August 29, 1977
Re: Indian Point Unit No. 3
Docket No. 50-286

As requested by your letter of June 3, 1977, we have compared the current design of the Indian Point Unit No. 3 emergency power system with the staff positions stated in the enclosure to your letter. A detailed analysis which shows our facility design has equivalent capabilities and protective features to those stated in staff positions 1 and 2 is attached.

INDIAN POINT NO. 3

480V Safeguard buses #2A & #3A are normally supplied from the generator and in turn together supply a 50% train of safety related equipment (various offsite power source connections can be seen on the attached sketch SK-6868-1).

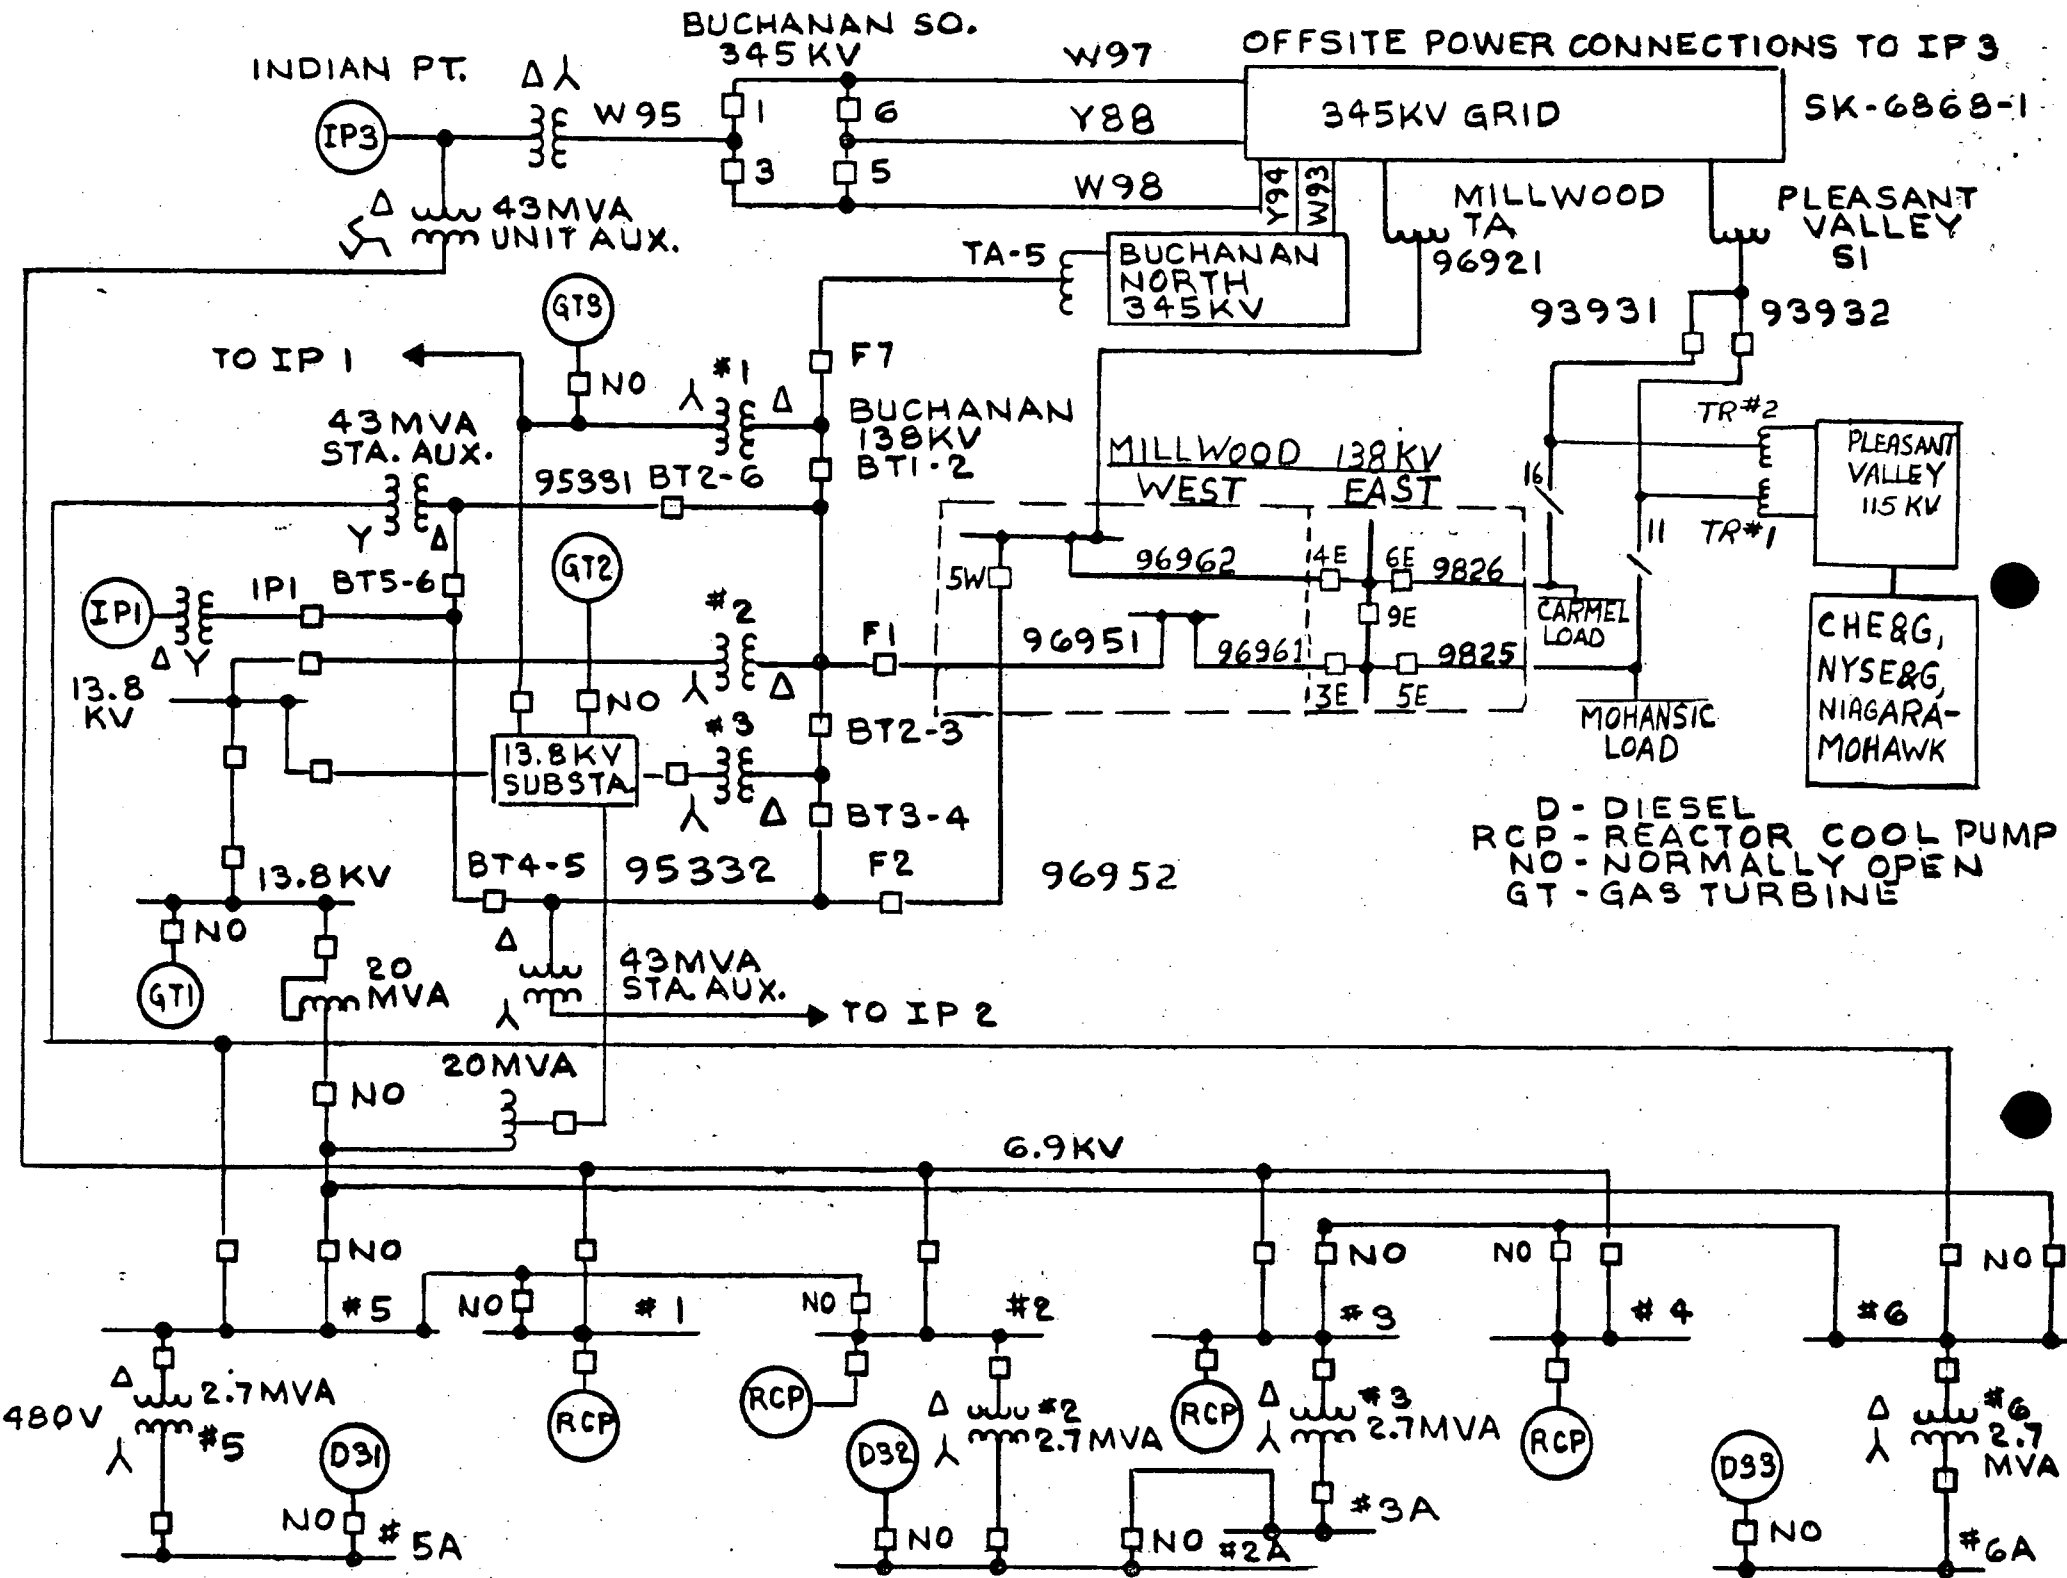
2. During normal plant operation, 480V safeguard buses #5A & #6A are supplied from the 138KV grid and in turn each supplies a 50% train of safety related equipment.

The worst generator terminal voltage degradation that will not cause a unit trip would result from large reactive power flow into the generator due to abnormally low generator excitation, such that conditions are just outside the loss-of-field relay trip characteristic. This condition will result in low voltage on the Buchanan 345KV S/S South bus (97% or 336KV). Buses #2A & #3A will be at 94%V or higher and buses #5A & #6A will be virtually normal.

The worst 138KV degradation would result if Buchanan 345/138KV transformer TA5 is lost coincident with loss of 138KV feeder 96962 and associated Millwood 345/138KV transformer TA. During this contingency the Buchanan 138KV offsite power supply bus will be supplied only from Pleasant Valley 345KV S/S (S1 transformer) and Pleasant Valley 115KV S/S (transformers 1 & 2) through 138KV feeder 96951.

The Buchanan S/S 345KV South bus voltage is calculated at 102% immediately after the contingency, but generator voltage regulator response will immediately restore voltage to normal. Under this condition the voltage on buses #2A & #3A are normal and buses #5A & #6A will be at 90% or higher.
